Recall Campaign 06V-277: Inspect Rear Shock Absorbers

E60, E61 (5 Series)

E63, E64 (6 Series)

E65, E66 (7 Series)

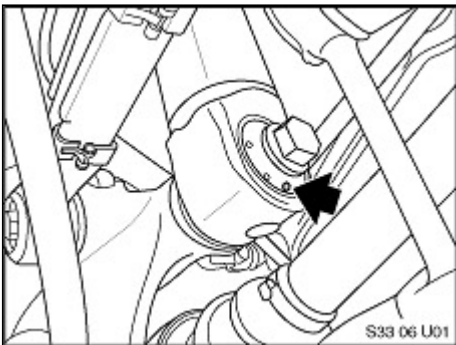
With the vehicle properly supported on a lift, inspect the rear shock absorbers for a blue paint dot as shown in the illustration.

If the blue dot is present, no further action is necessary.

If there is no blue paint dot, the rear shock absorbers must be replaced.

LABEL INSTRUCTIONS

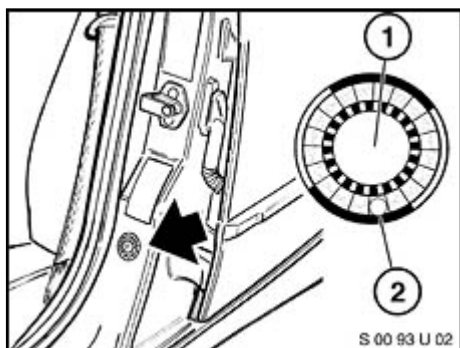
This Recall Campaign has been assigned code number **471**. After the vehicle has been checked, and corrected if necessary, obtain a label (SD 92-295) and:

- emboss your BMW dealer warranty number in the middle of the label (1);
- punch out code number **471(2)** printed on the label and,
- affix the label to the **B** pillar as shown.

If the vehicle already has a label from a previous Service Action/Recall Campaign, affix the new label next to the old one. Do not affix one label on top of another one because a number from an underlying label could appear in the punched-out hole of the new label.
